Information note

NEO-8Q-M8x-M9x-D9x documentation update Topic

> UBX-22039049 C1-Public

19 December 2022

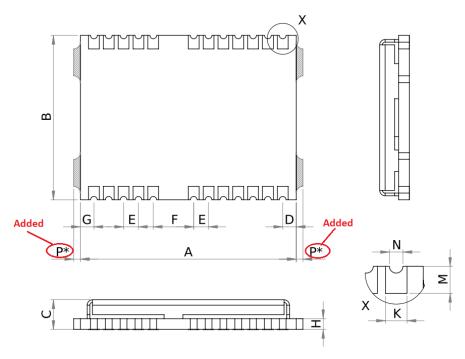
The dimension of residual tabs from de-panelling procedure has been added to the mechanical drawing of u-blox NEO-8Q, NEO-M8x, NEO-M9x, and NEO-D9x modules. Refer to the symbol **P*** shown in the below picture.

The mechanical picture of the de-paneling residual tabs (P*) is an approximate representation. The shape and position of the residual tab may vary.

When designing the component keep-out area, note that the de-paneling residual tabs can be on either side of the module (not both).

There is no change of NEO form factor overall dimensions (12.2 \times 16.0 \times 2.4 mm) despite the additional residual tab information.

All relevant Data sheets listed in Related documentation will be updated with the latest mechanical drawing including additional residual tab information.
